U.S. Department of Energy
Office of River Protection

U.S. DEPARTMENT OF ENERGY (DOE), OFFICE OF RIVER PROTECTION (ORP)
SUBMITTAL OF CLOSURE REPORTS FOR SIX EMISSION UNITS IN THE HANFORD
SITE AIR OPERATING PERMIT (AOP), PERMIT NUMBER 00-05-006/LICENSE NUMBER
FF-01

Report of Closure for Emission Units

| 9. Title Isolate and remove 241-AW Primary Ventilation | 10. Bldg. / Facility No. 241-AW | 11. Equipment / Component ID AW Primary Ventilation System | 12. Approval Designator N/A |

Document/Drawing No. H-14-030013 Sheet 2 Revision 9

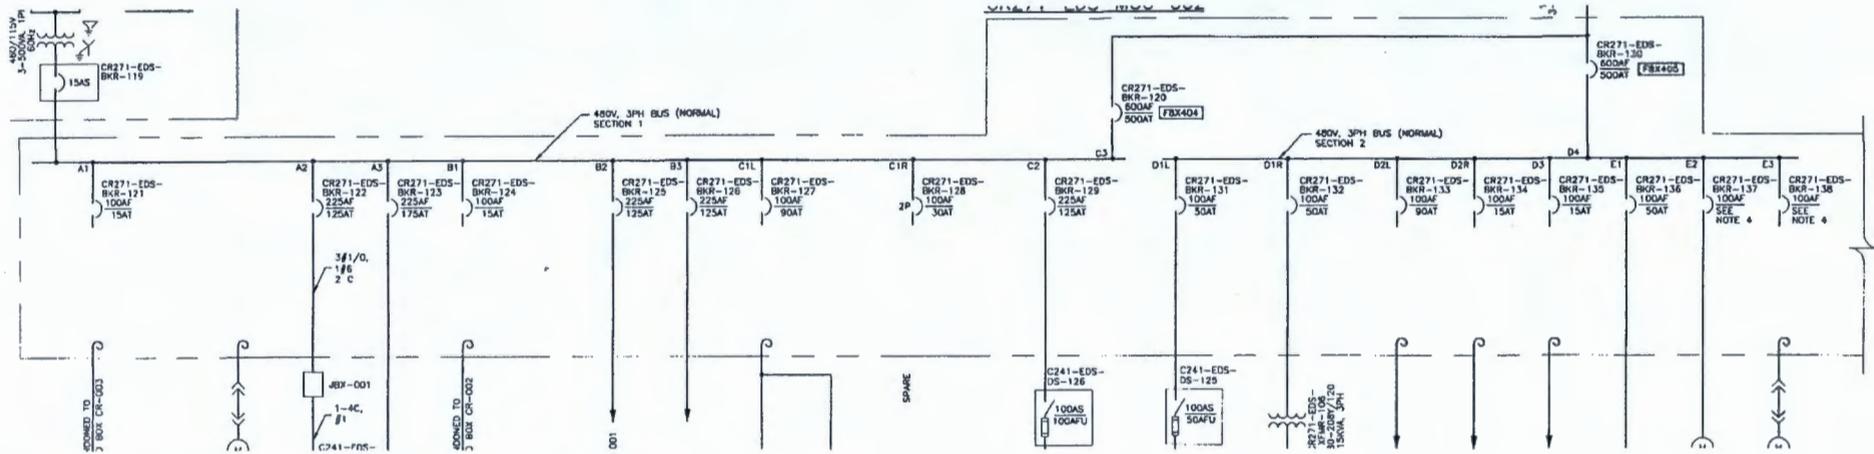
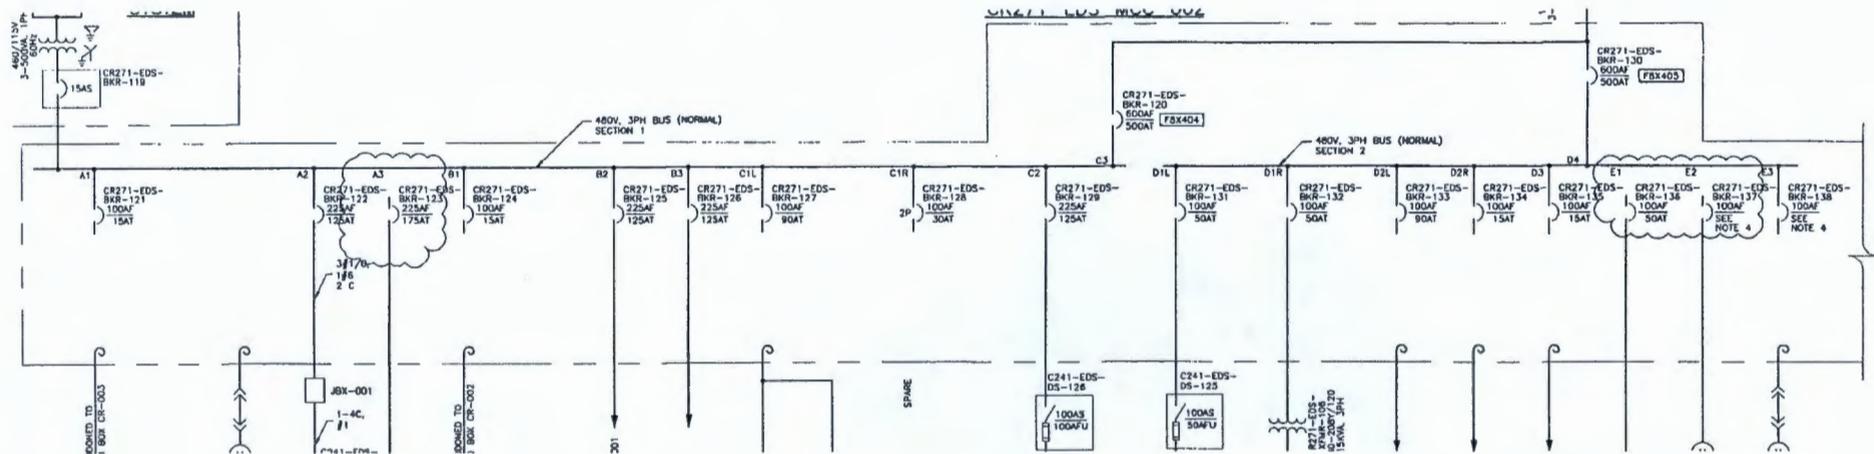
IS: DISCONNECT BREAKERS FROM BUS AS SHOWN

Document/Drawing No. H-14-030013 Sheet 3 Revision 6

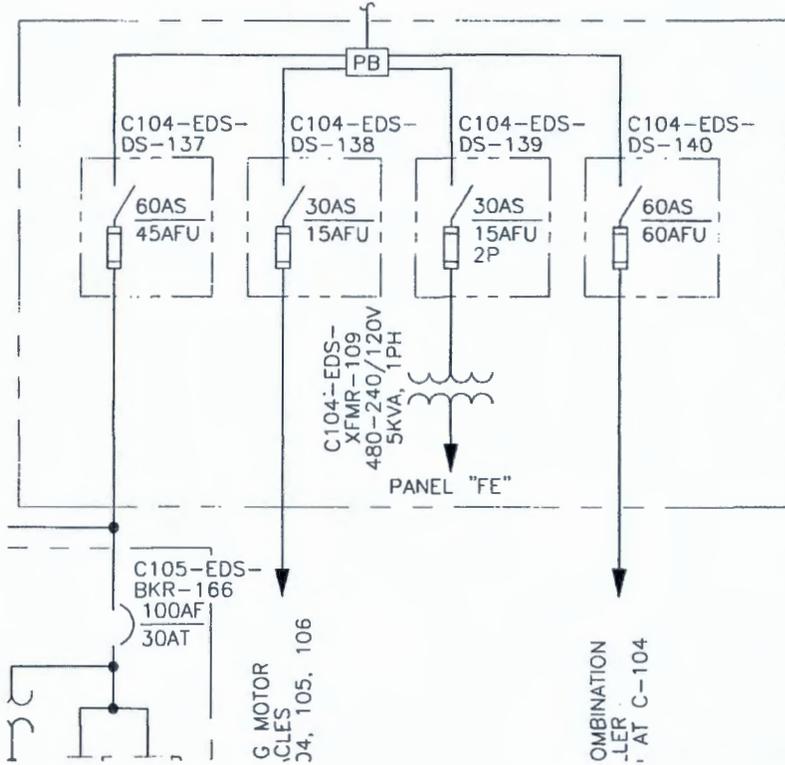
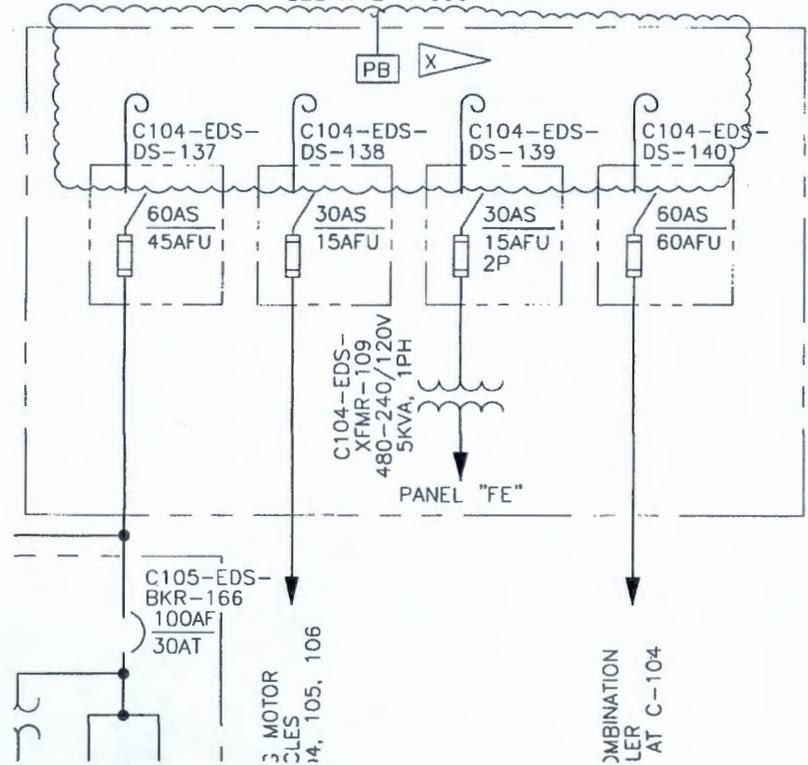
The disconnection of the disconnect switches from the pull box (PB) as shown on sheet 6 of this ECN are to ensure the power is isolated to the disconnects to allow removal from the EDS preventative maintenance data sheet. Due to the lack of space the wires shown coiled outside the box is solely for the clarity of the disconnection. A flag note "X" to be added as the next available note on the drawing will state the following:

NOTE "X." WIRES ARE DISCONNECTED AND SAFED OFF INSIDE THE PULL BOX.
